VE Study: Remedial Design of the Cuyahoga River Gorge Dam GLLA Project, Cuyahoga Falls, Ohio, EPA, LRB, Memphis District

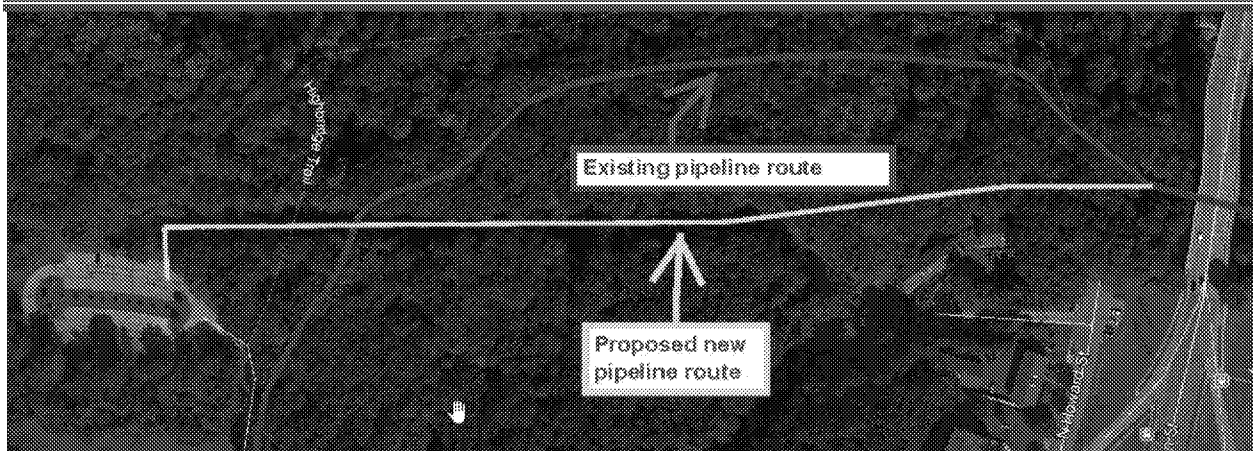
7. Comment No. (Speculation No. 39 – Optimize the length of the pipeline in the northwest corner, utilize electrical power lines):

- a. Consider dropping off the Highbridge Trail and connecting to the electrical power line right-of-way just west of Main Street to reduce the overall length of pipeline. See figure.
